Project: 23-10 - Travers Park Reno: Phase 1
2016 Pine Street
Sandpoint, Idaho 83864

Prime Contract Change Order #011: Safety Fence, Credit:Bike Rack, Seed & Boulders

Prime Contract Potential Change Order #052: CE #107 - Safety Fence

A PLAYGROUND CONSTRUCTION
PLAN BASE BID

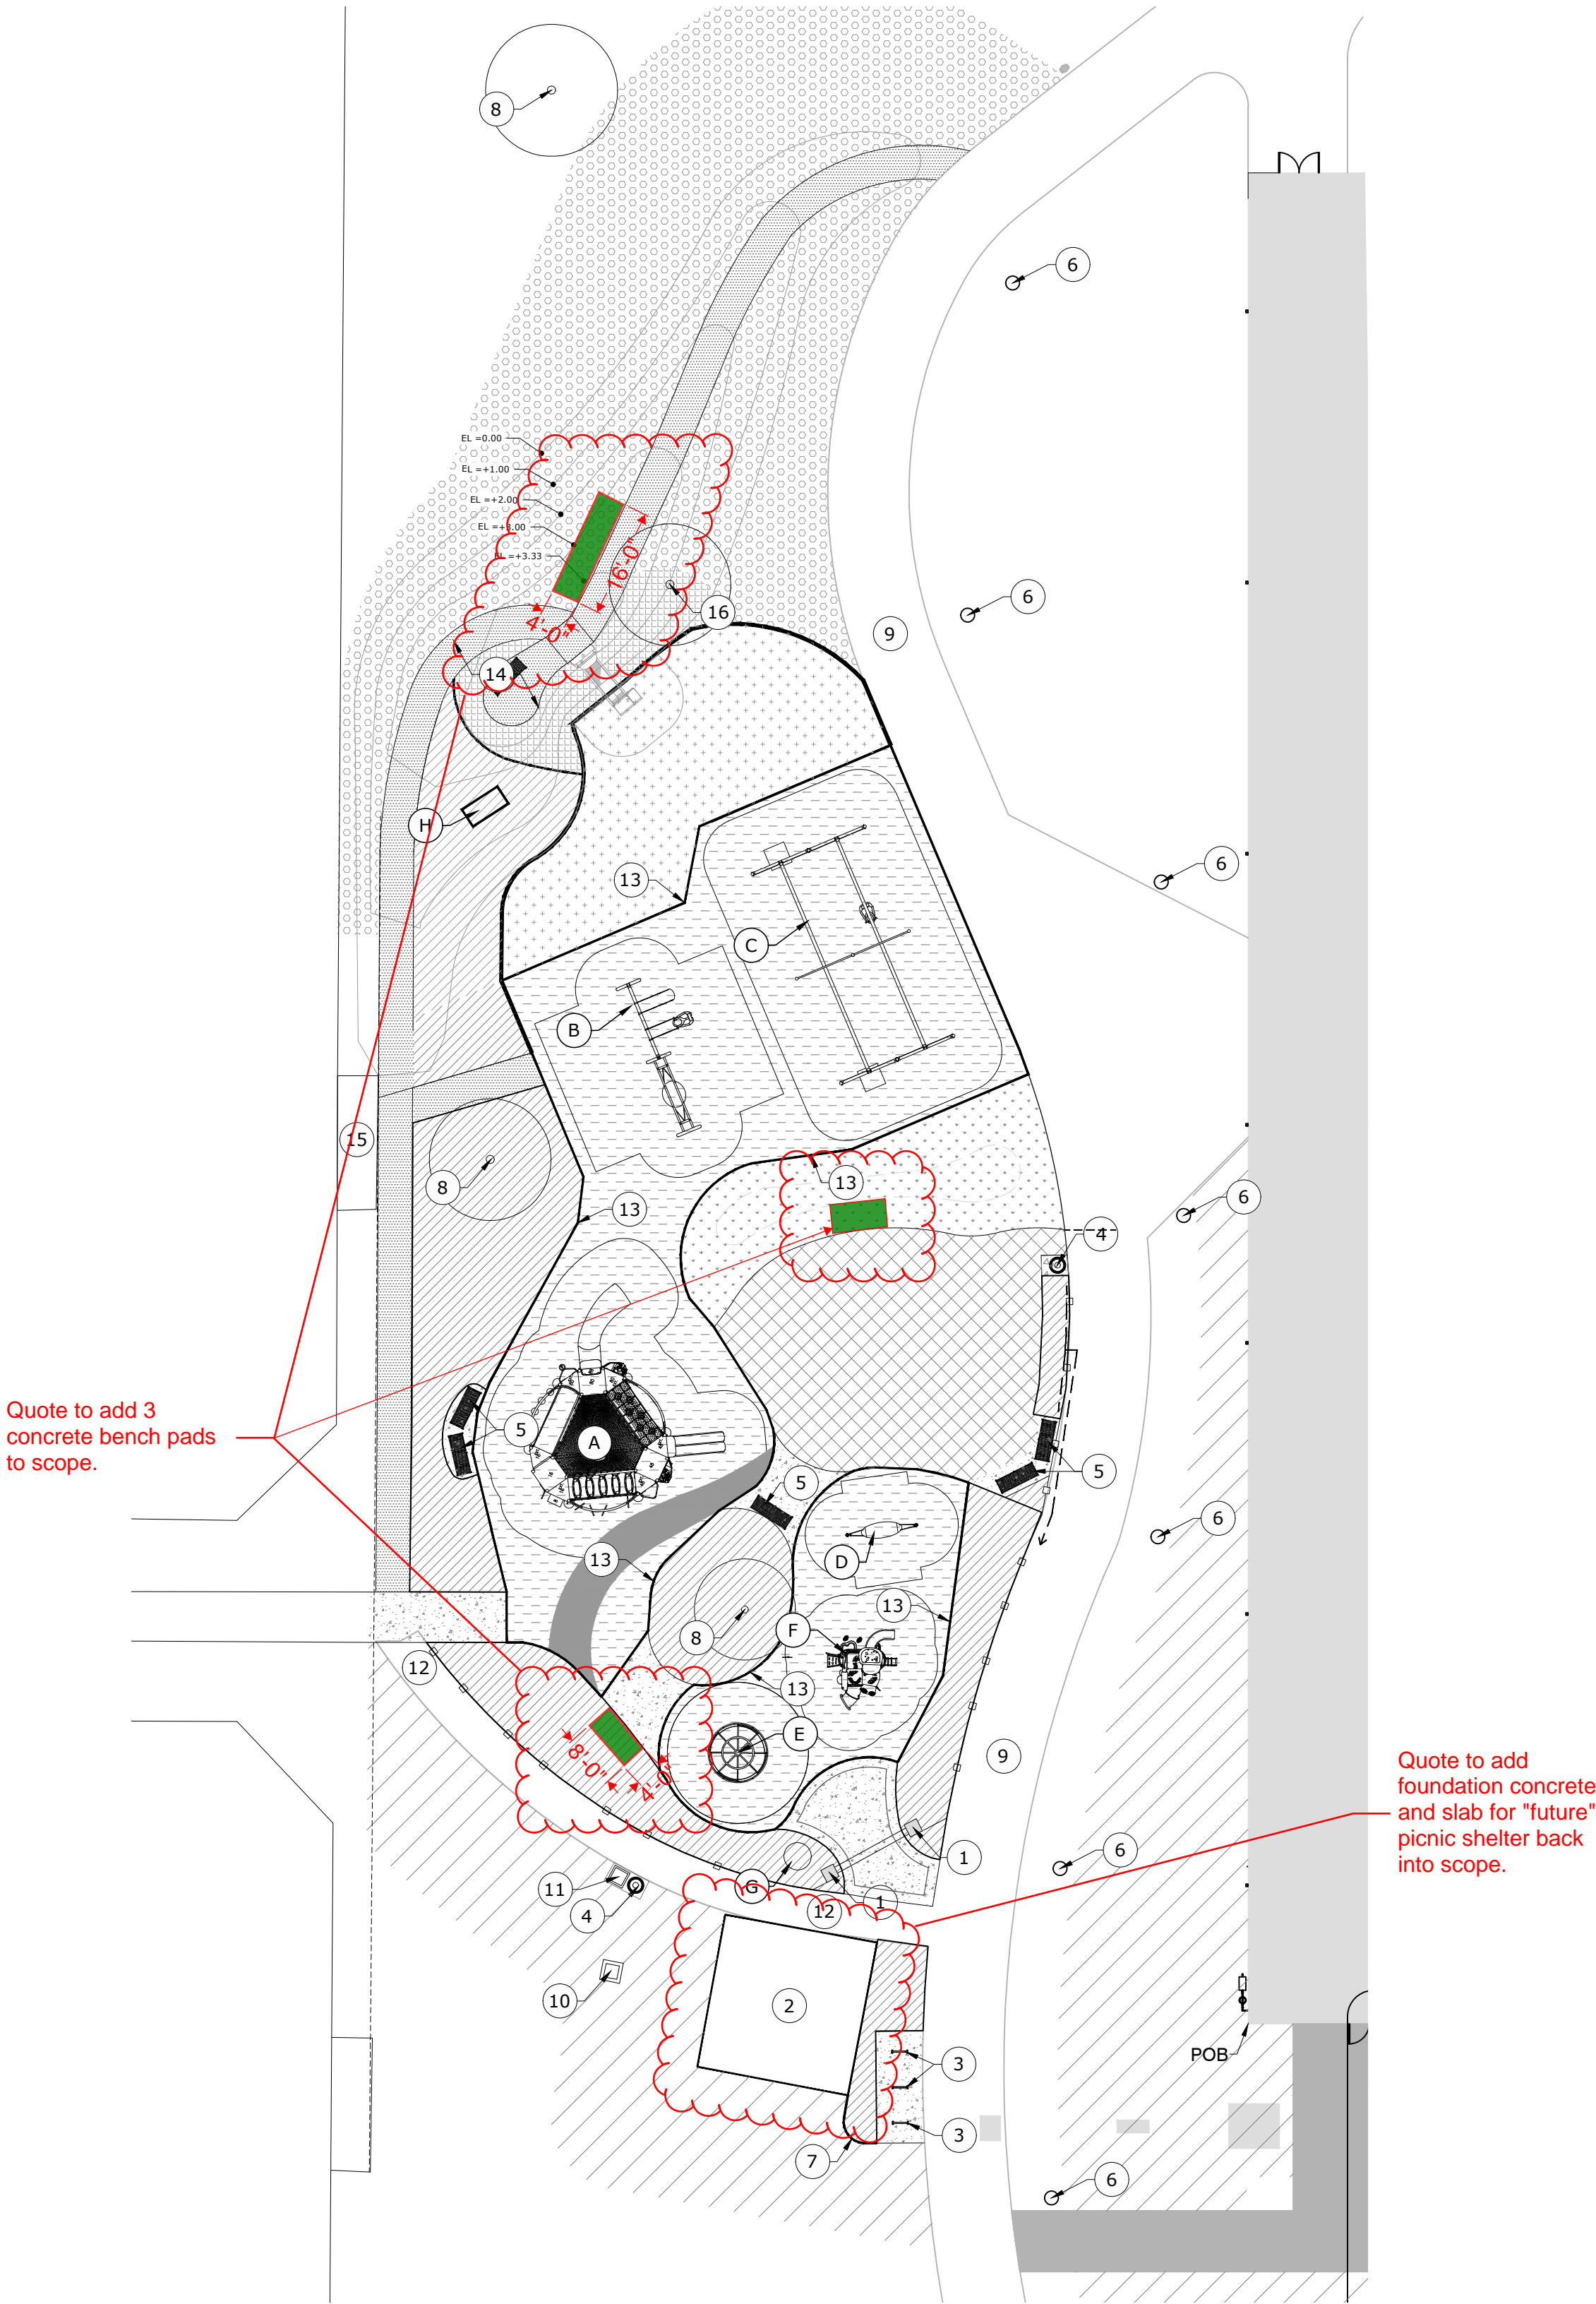
Add:

Description
Added Sidewalk for Benches

18 OZ. LIGHT BLUE VINYL BACK DROPS
WELDED EDGES, GROMS @ 1' CENTERS TOP & ENDS
DUPREE / TRAVERS PARK
8/8/2024 REVISED FROM 12/22/2023

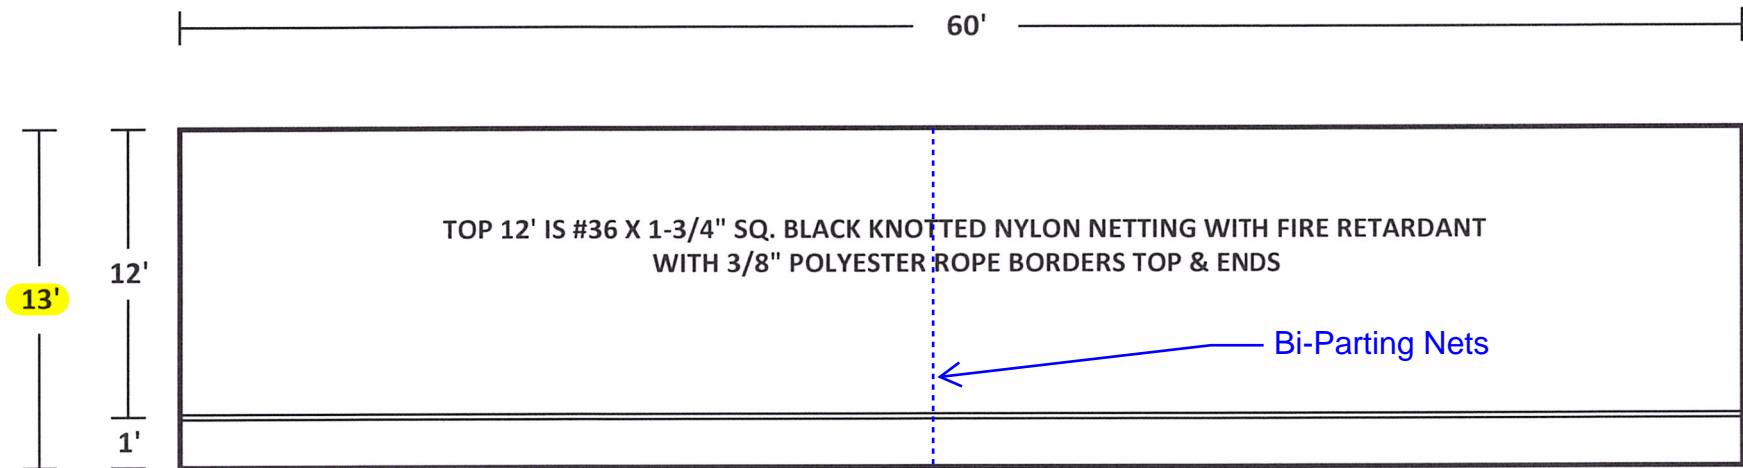
- Eliminate California Corners: See Dupree's New Door Design
- Vinyl Curtains to be Blue: See Dupree's Sample Options
- Add 3'-6" x 7'-0" Openings: Add \$1,915.00 for New Door Configuration
- Add Vision Panels from 4'-6" to 7'-0" AFF: \$4,715.00
- Bottom of Vinyl Backdrops to Sit on the Ground: N/C
- Curtain Cables to Remain at 10' High – Supported Every 20' Intervals: N/C
- Provide Minimum 8'-0" Section Movable for Pickleball Equipment: See Design Change
- Provide Pricing for Split Bracket Pulleys: Not an option
- ~~Provide Stainless Steel Cables & Hardware: Add \$4,400.00~~

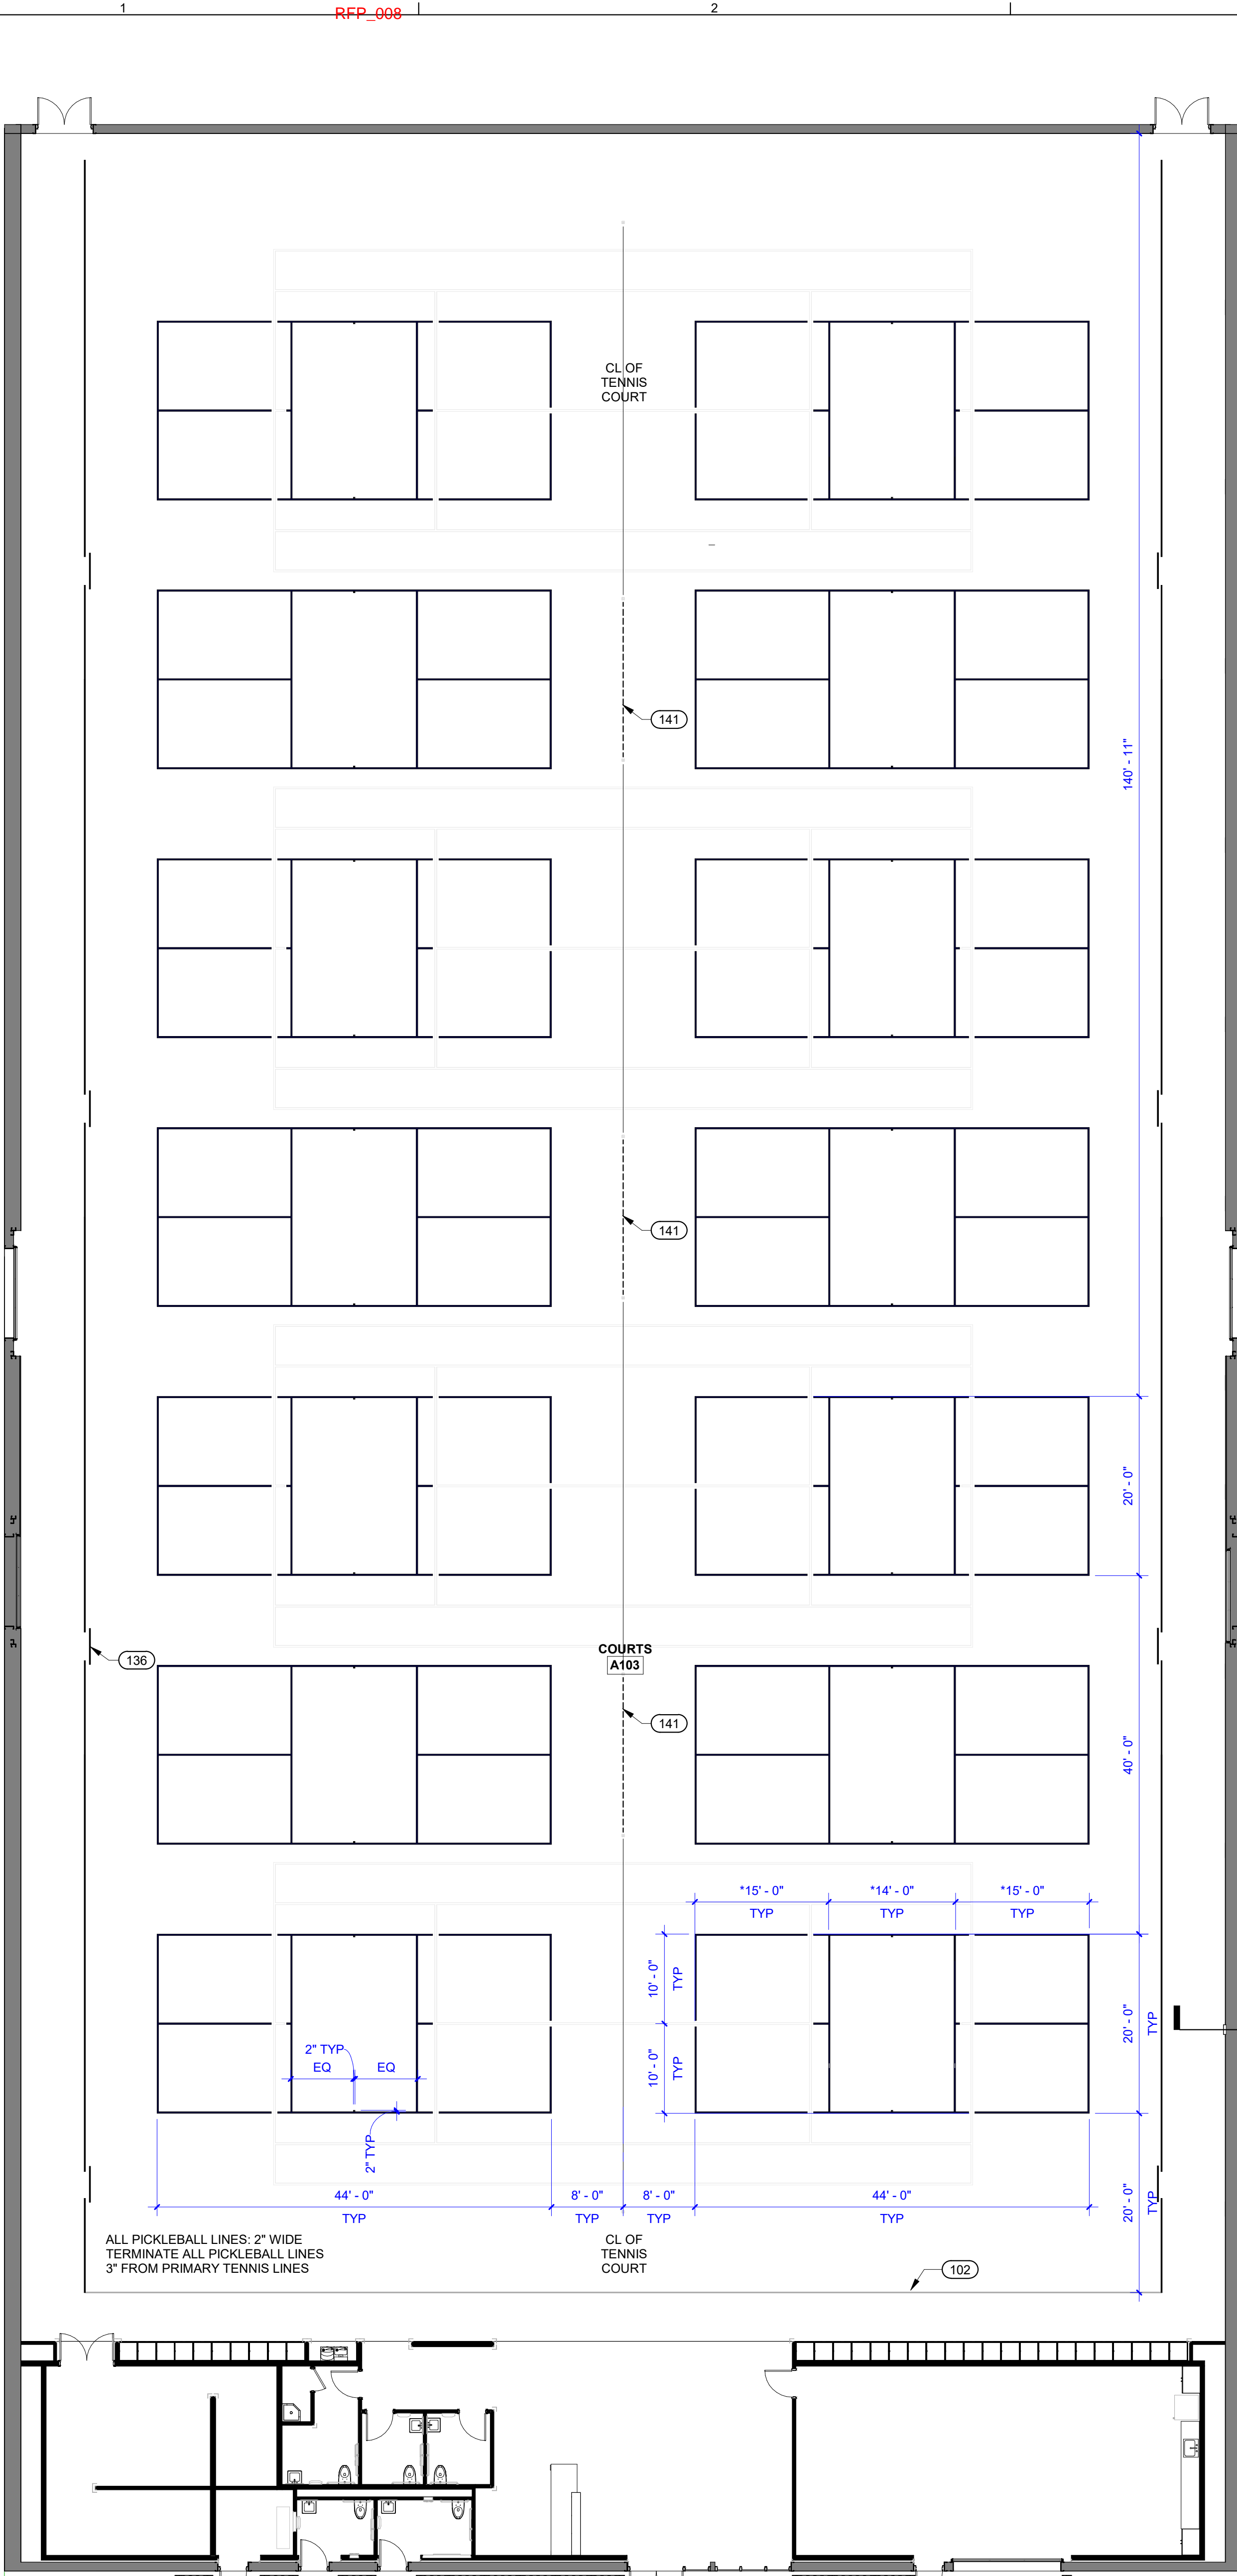
Maeve and I just met and reviewed the PCO. Can you provide us a little more breakdown as follows: Provide a pricing for a credit for the gable net that will block balls from going over community room/lobby.

Provide a breakdown of the pricing for the add of the 3'-6"x7'-0" openings vs. the credit of the California corners.

Provide price for vision panels in "doors". What if they were solid?

Provide a breakdown for the vision panel costs. Is it possible to derive a linear ft cost? Is it half the cost if we only install half the length of vision panel?

Provide a breakdown of the stainless steel cable for both curtains and nets. Confirm the material that is currently in the bid for cable and the hardware.

We will likely not accept the Tie-back straps nor the modified tennis nets. We also want to remove the steel cable, but may want to keep the stainless steel hardware at the nets, but not the curtains.
